Addendum 2

Questions & Answers

GOVERNMENT OF BERMUDA

Ministry of Public Works

Section C-C
Schnitt C-C

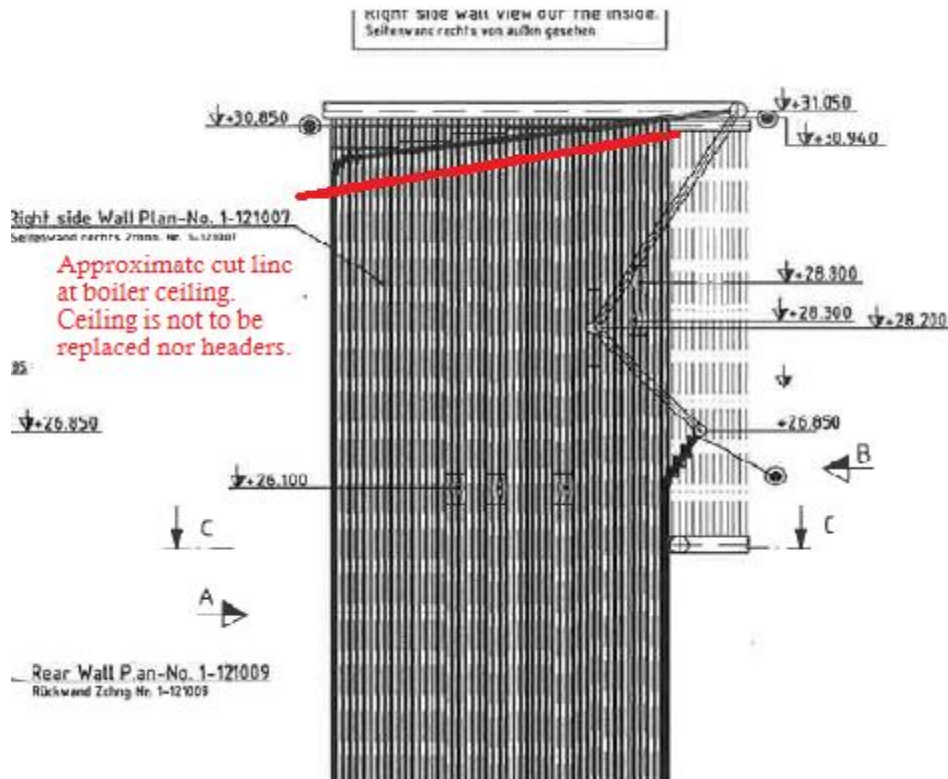
- a. Tube size and spacing can be found from drawings and documents provided
- b. Approximate Bottom Cut line for waterwalls are depicted below.
- c.

See red marker on drawing for approximate cut for Rearwall bottom.
Note that the cut should be made just below the measuring instrument between 17.5 and 17.7m. (values are approximation)

The cut on the bottom front wall shall be made above the curve bend just below the measuring instrument between 18.1 and 18.6m (values are approximations)

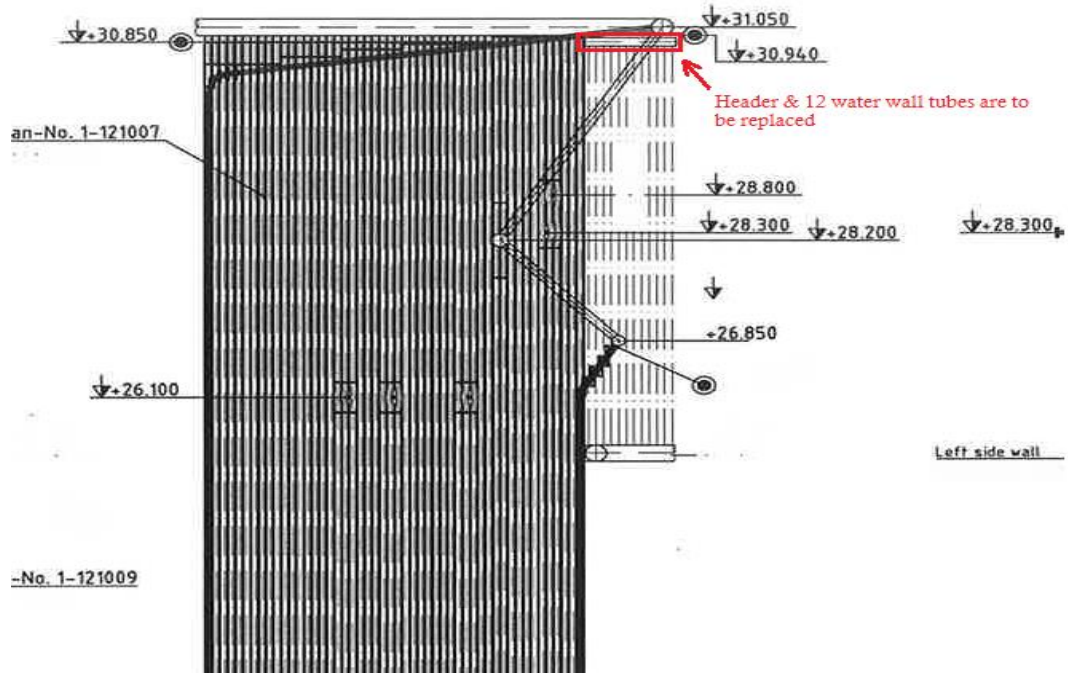
- d. Inconel overlay shall start approximately 12 inches below the top tile refractory line. The overlay shall encompass all of the waterwall to the top of the header of the furnace.

e. 12 Additional waterwall tubes

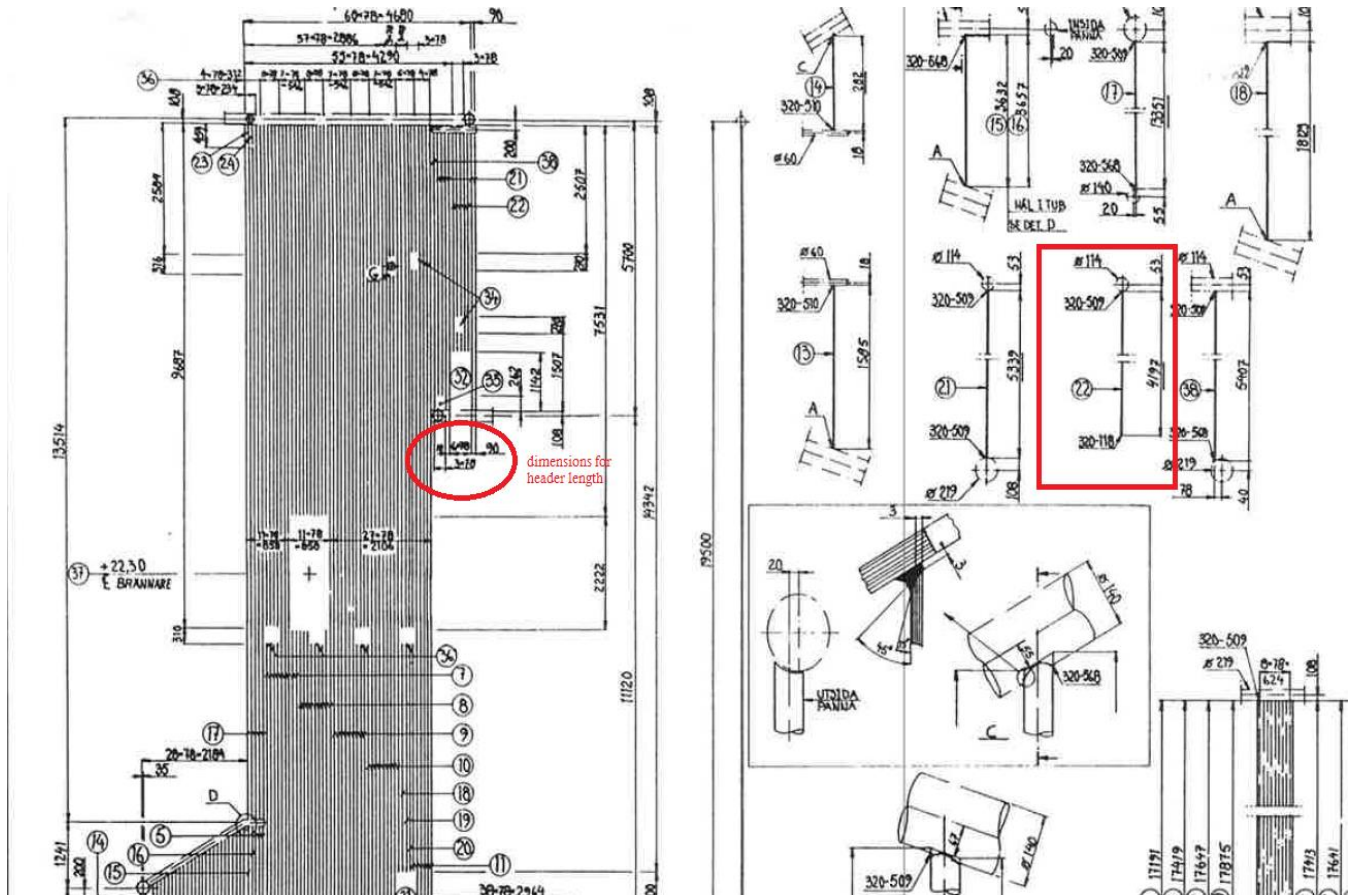
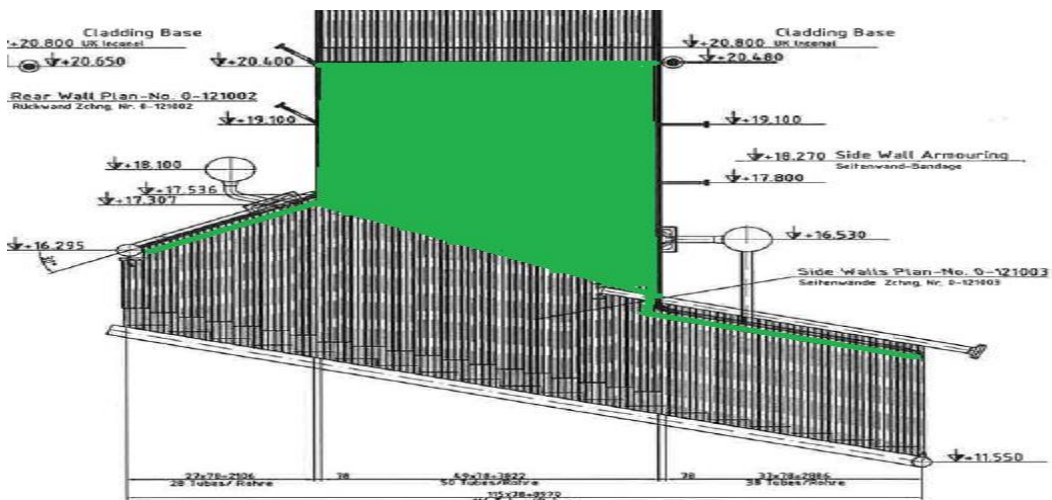
- i. The twelve tubes can be loose tubes or as fabricated panel, it is the choice of the vendor.
- ii. Header dimensions are provided below (see drawings 324-4081 & 320-509 for clearer view and welding details):
